EPC STORMWATER REVIEW COMMENTS
IN ORANGE BOXES WITH BLACK TEXT

UDON SOUTH SITE DEVELOPMENT PLAN 12265 HIGHWAY 94

COVER SHEET

ROCK CHUTE TYPICAL SECTION - FOREBAY BERM/TRICKLE CHANNEL
1" = 5'

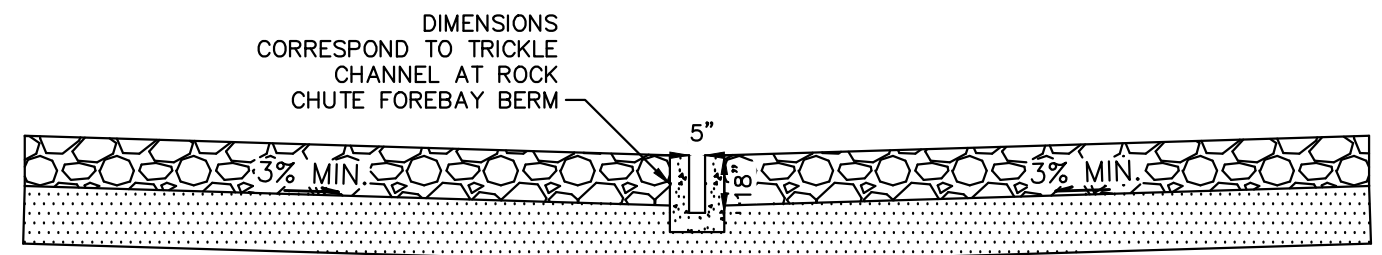
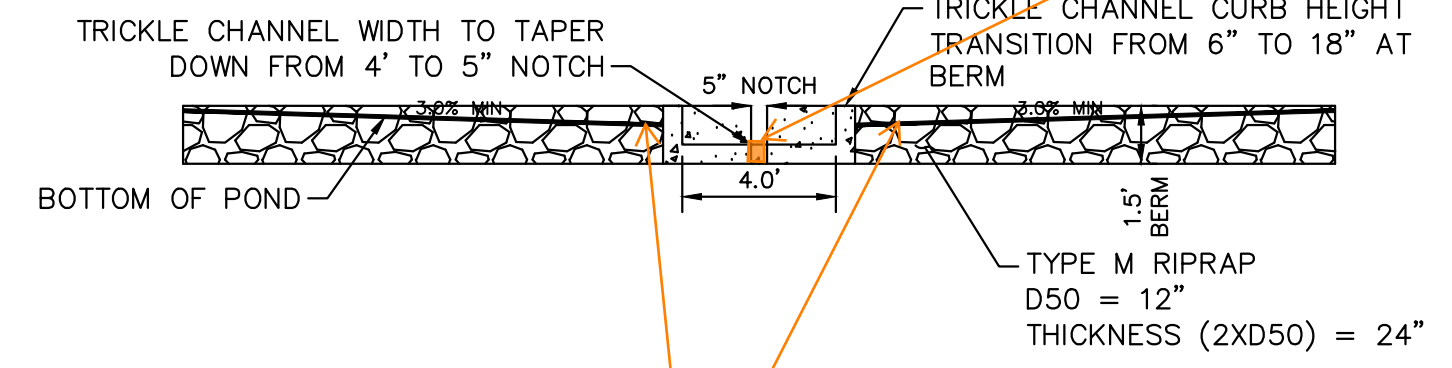
The bottom of the forebay notch should be at the same elevation as the flow line of the trickle channel. But this detail shows the notch extending down below the flowline of the TC, such that the forebay would hold water. Please revise.

Bottom of pond has to be graded to the top of the trickle channel. Doing so on this detail will still create a transition that needs to be shown more clearly (per my comments on the last review). Make sure that the area just downstream of the forebay berm does not hold water (ie. drains to the trickle channel).

PHOTOMETRIC PLAN
SHEET 16 OF 20

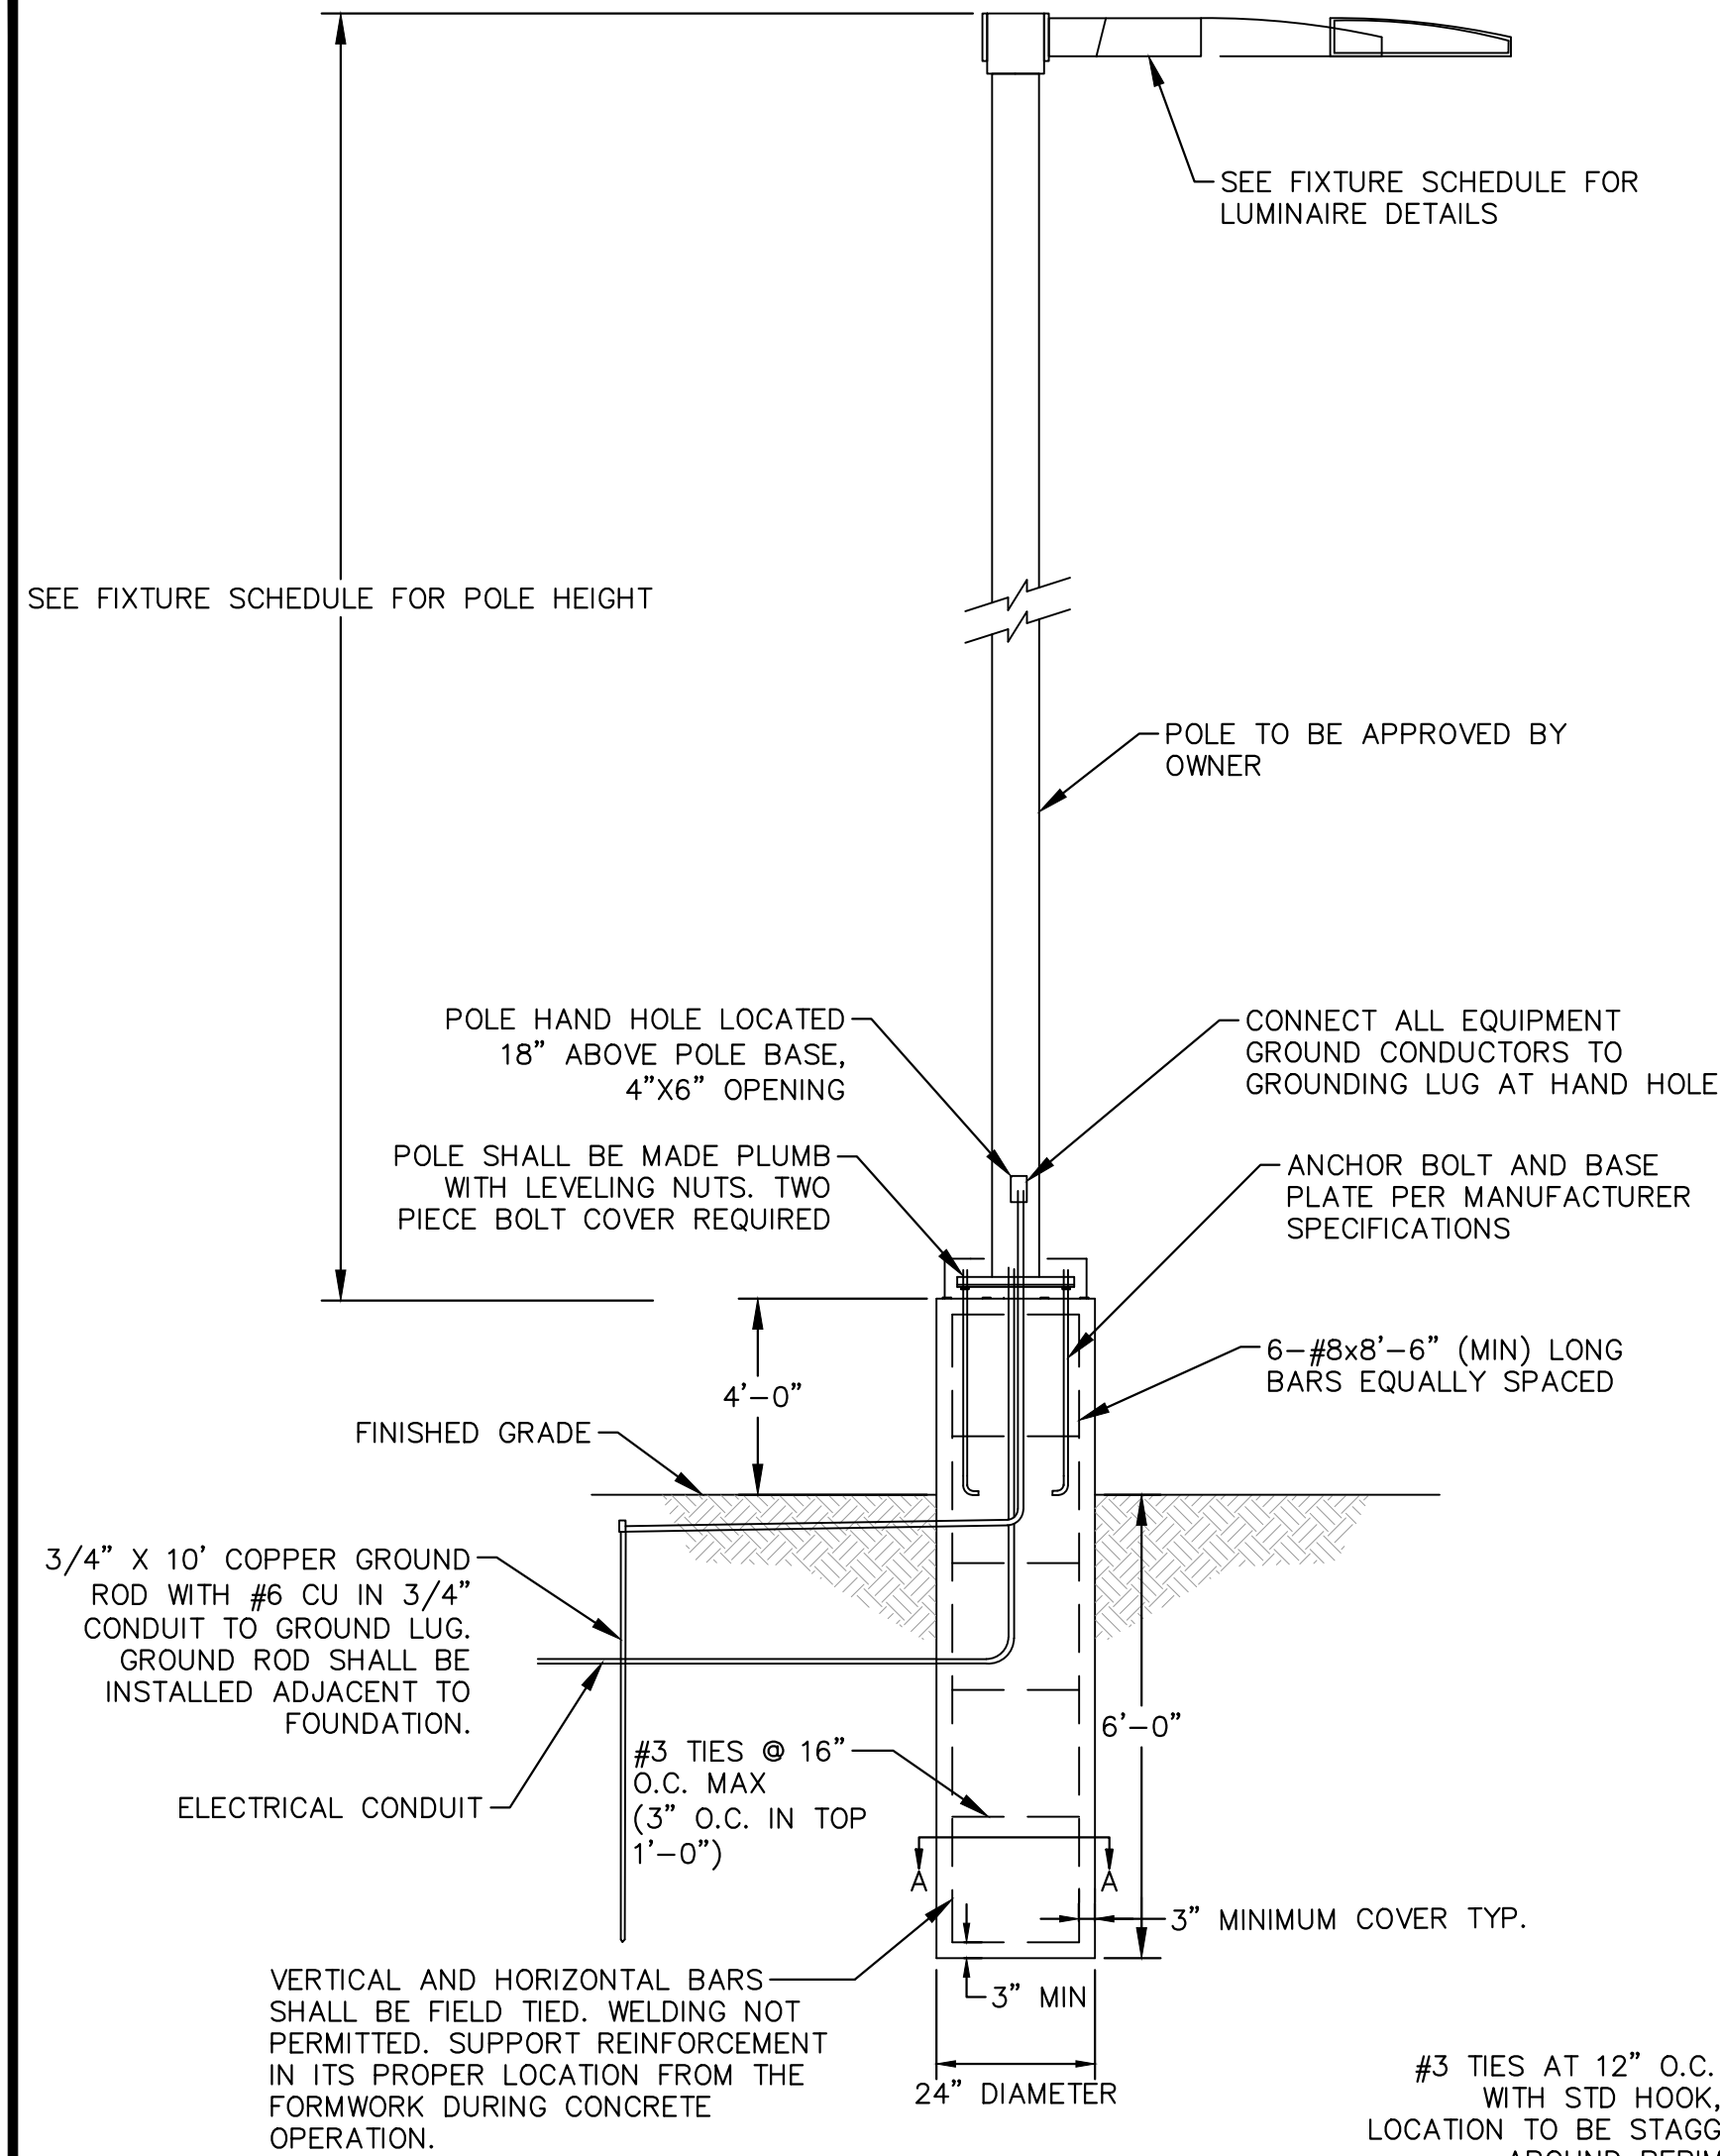
Per § 6.2.3.B.1.d, Maximum on-site lighting levels shall not exceed 10 foot candles.
 Per § 6.2.3.B.1.e, Light levels measured at the property line of the development site adjacent to public right of way shall not exceed 0.1 foot candles.

3 CHAIN LINK FENCE
NTS

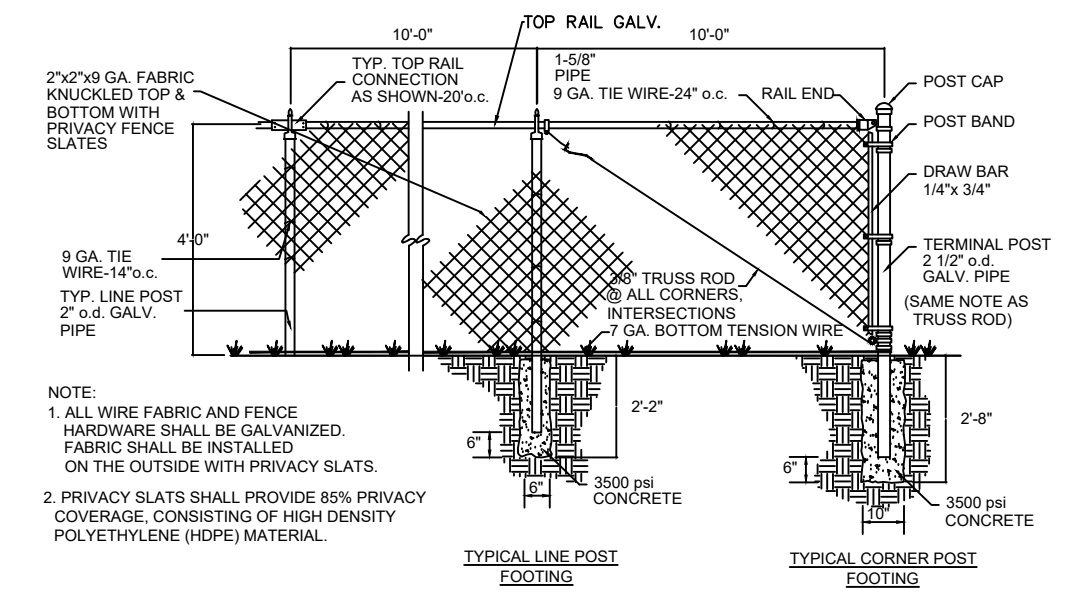
Fence surrounding storage area shall be at least 6' tall and 100% opaque.
Chain link with privacy slats does not meet the intent of the code.
